## IEEE P802.15 Wireless Personal Area Networks

Project	IEEE P802.15 Working Group for Wireless Personal Area Networks (WPANs)	
Title	<b>TG3 SB1 comment resolution</b>	
Date Submitted	[13 February, 2003]	
Source	[James P. K. Gilb] [Apparent Technologies] [15373 Innovation Drive, #210, San Diego, CA 92129]	Voice: [858-485-6401] Fax: [858-485-6406] E-mail: [gilb@ieee.org]
Re:	[]	
Abstract	[This document is a record of comment resolutions for SB1.]	
Purpose	[To provide a record of the comment resolution for SB1.]	
Notice	This document has been prepared to assist the IEEE P802.15. It is offered as a basis for discussion and is not binding on the contributing individual(s) or organization(s). The material in this document is subject to change in form and content after further study. The contributor(s) reserve(s) the right to add, amend or withdraw material contained herein.	
Release	The contributor acknowledges and accepts that this contribution becomes the property of IEEE and may be made publicly available by P802.15.

## 1. Conference calls

**Figure 6—MSC for acquiring DEV IEs using the Probe Request command.**

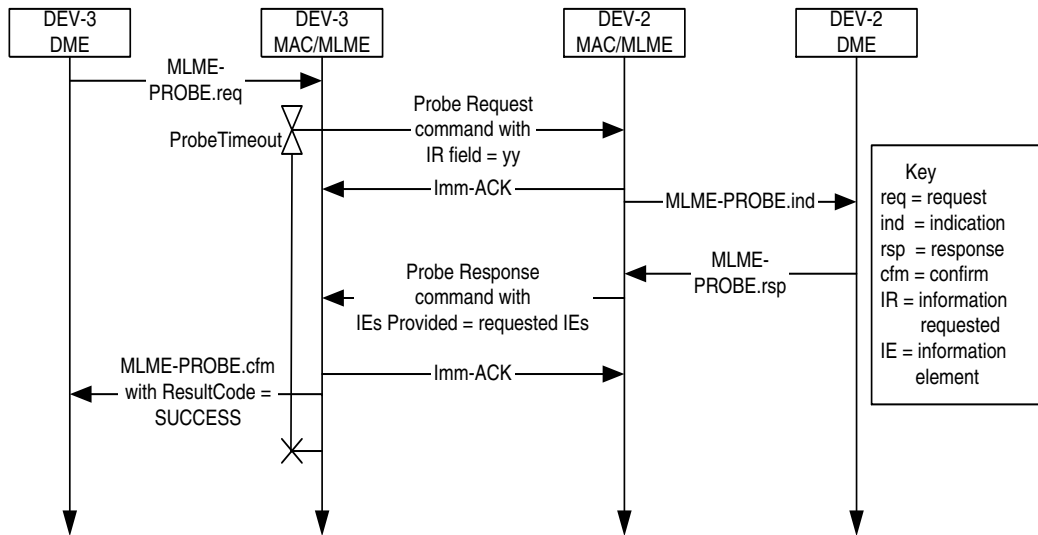
Replace Clause 8.9.2 with the following text:

Figure 6 illustrates the sequence of messages involved in acquiring DEV IEs from a target DEV using the Probe Request command.

**Figure 8—CTRq time unit covering multiple frames with CTRq TU MIFS = 1**

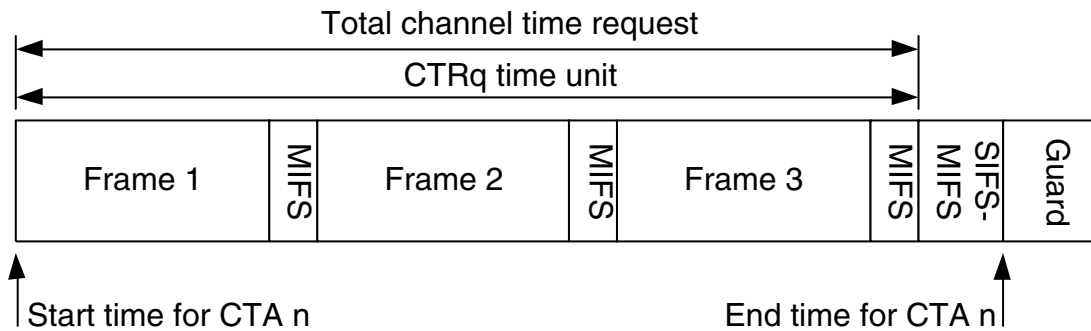
CID 682 - Needed to add one more figure, see also 03/059r0 for complete section. The new figure and text are:

Figure 8 shows a multi-frame CTRq with the CTRq TU MIFS field set to 1.

**Figure 9—PNC sending the piconet services command to a newly associated DEV in response to a request in the association proces.**

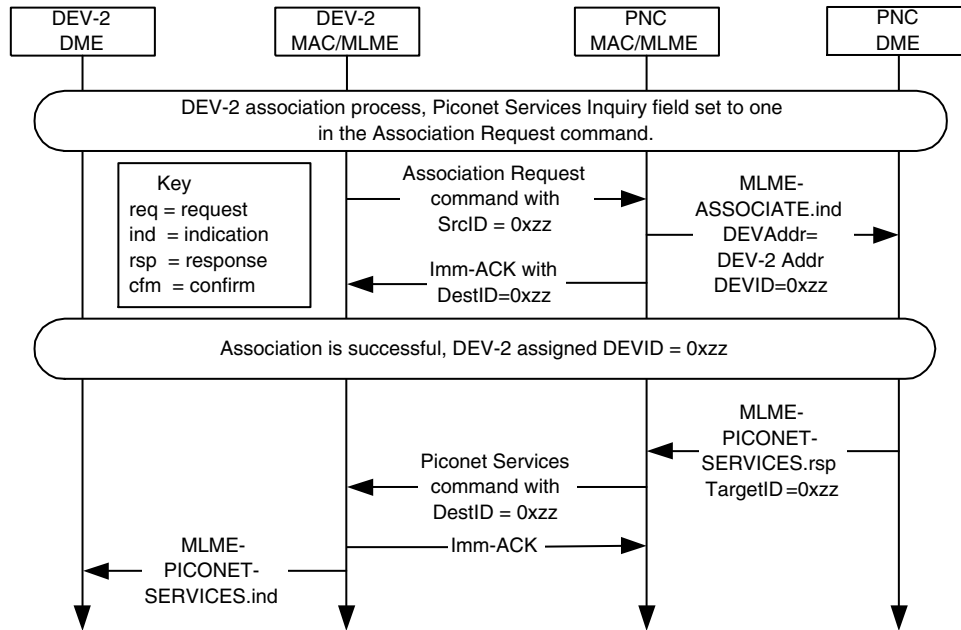
Accept in principle “Change to ‘If the DEV sets the piconet services inquiry bit, the PNC shall send the piconet services command, 7.5.4.6, with DestID set to newly assigned DEVID after that PNC

has received the second Association Request command from the DEV, {xref}. This process is illustrated in {figure xx}.' and add new MSC as shown in 03/032r10."

**Figure 15—Channel time request for frames with immediate ACKs**

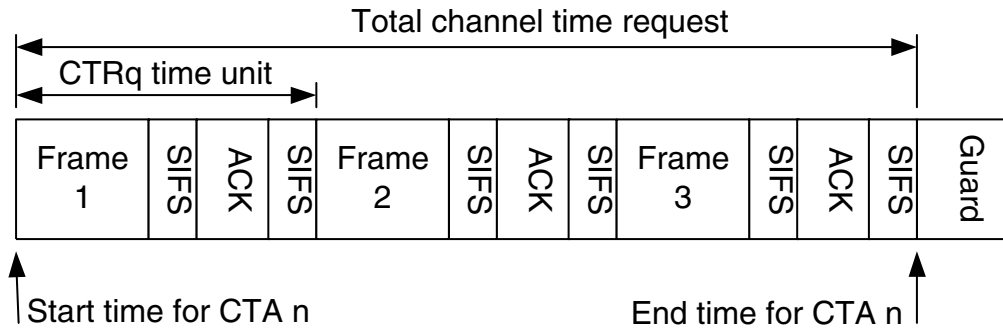
CID 682: - **Suggest accept in principle:** The inclusion of MIFS changed the CTR calculations, but the changes were not reflected in 8.4.4.6. '1)Change b3 in Figure 79 from "stream termination" to "MIFS CTRq TU". 2)Replace page 152, line 12 with:

requests. Figure 15 (was #108) shows an example of channel time being requested for a CTA where Imm-ACKs are used.
